City of Springfield

Landmarks Board

June 11, 2025

LOCATION: 1430 East Walnut Street

Item 2 - Dimensional
Letters MIDTOWN
CARNEGIE

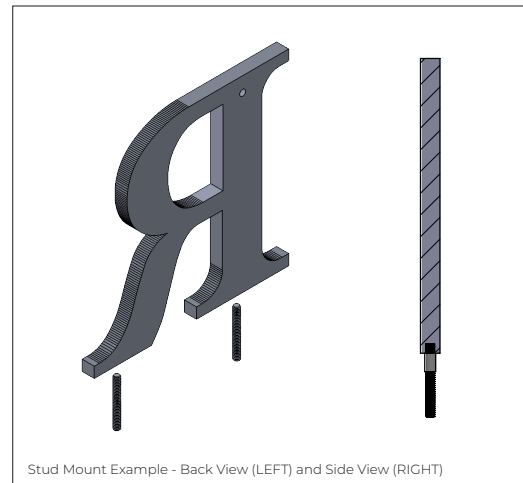
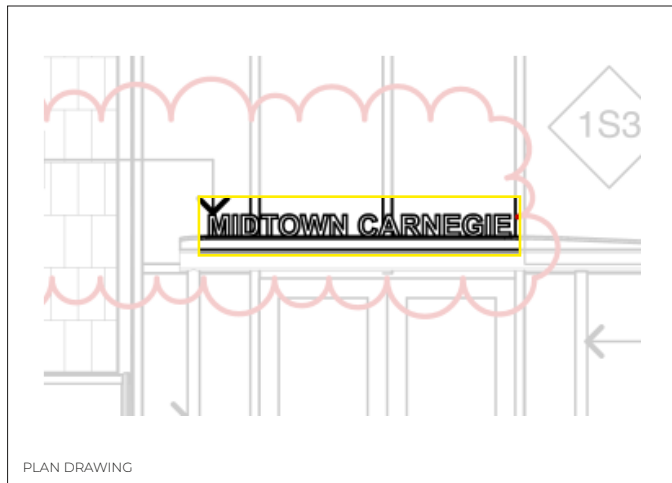
This should have been 6" in the
Proposal request. 8" was a
mistake. Revise to 6", verify
length of text will fit on available
space on canopy edge.
